Galway Commuter Coalition
Salthill,
Co. Galway

Public Consultation Murrough Masterplan - Máistirphlean Muirbheach

Introduction

Map of proposed active travel & permeability measures in Murrough

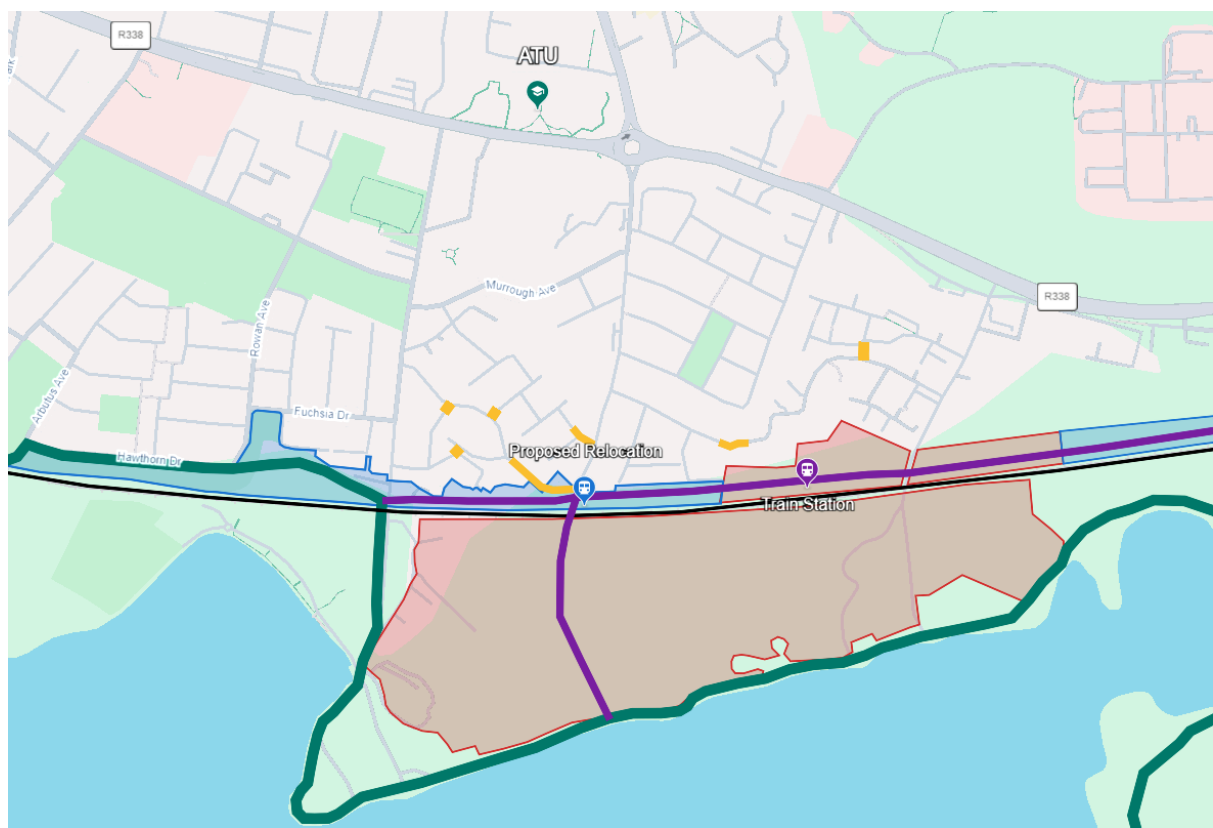
We strongly believe the undeveloped land on the north and south of the rail corridor can easily facilitate double tracking (also an AISRR objective), the proposed Murrough train station, future additional commuter stops and active travel links. We believe that this objective on additional active travel links strongly aligns with GCC's stated development goals. It would also align with the proposed RA greenway at lands to the north of the rail line at Renmore.

We believe that this existing land, that lies north of the rail line, which is not currently covered by the Murrough masterplan should be rezoned to a new zoning type. We propose this would be designated:

Zoning Objective: <u>Sustainable Transport, Recreation & Amenity. - STRA</u>	
To provide for and protect current/future sustainable transport corridors, recreational uses, open space, amenity uses, natural heritage and biodiversity	
Uses which are compatible with and contribute to the zoning objective, for example:	- Public transportation facility - Public transportation infrastructure - Active transportation infrastructure - Outdoor recreation
Uses which may contribute to the zoning objectives, dependent on the STRA location and scale of development, for example:	- Development of buildings of a recreational, cultural or educational nature - Public utilities - Allotments - Applicable to lands in this zoning category that are used to provide public transport services: - Coffee Shop/Tea Room - Restaurant - Shop $\leq 200\text{m}^2$ - Digital Innovation Hub / Co-working Space - Business Enterprise Centre - Residential

The development of active travel infrastructure and outdoor recreation/amenity areas along this route should occur in tandem with the proposed double tracking and station planning of the rail line.

Map Changes

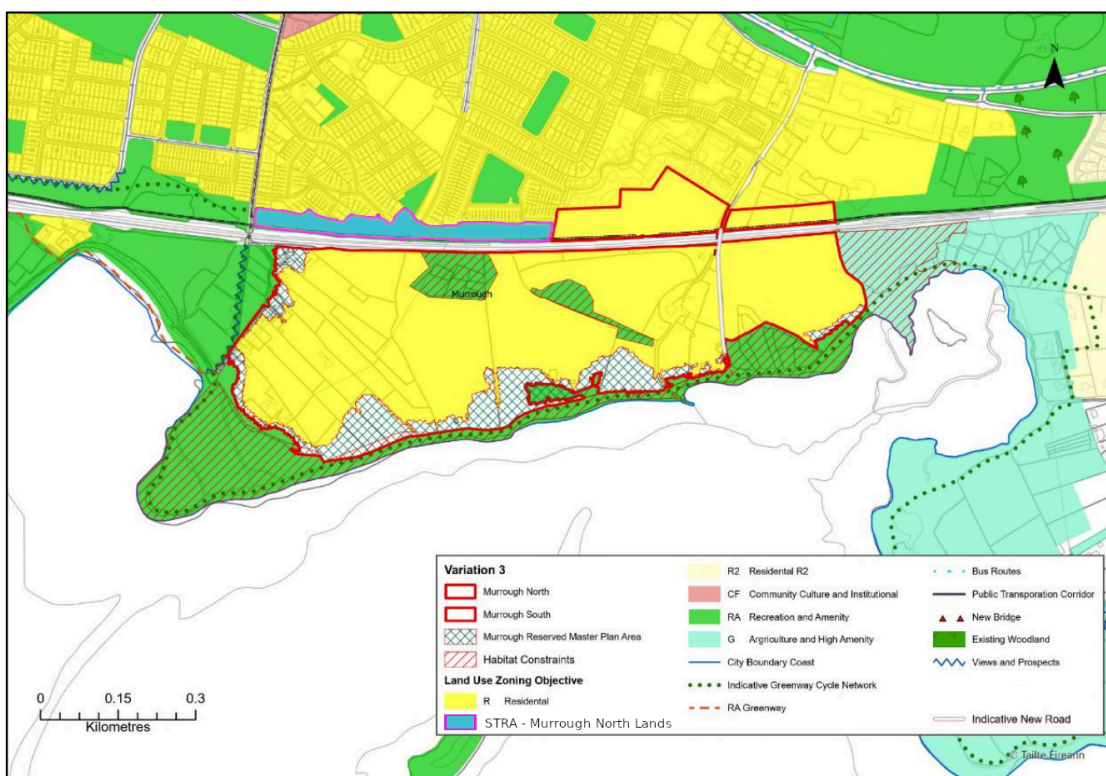
- Remove specific references to the proposed location of a train station. This should not be finalised until a Local Transport Plan and option selection report are produced with input from Iarnród Éireann.
- Zone additional lands north of the railway line as STRA, which are open to uses as sustainable transport corridors, recreation and amenity. In the absence of [STRA zoning](#), [RA zoning](#) could also be appropriate provided this zoning type is edited to allow for a '[public transportation facility](#)' as a compatible use. This landbank, and some of proposed zoned residential lands at the existing Murrough North, should be reserved for future dual tracking of the railway and active travel infrastructure.
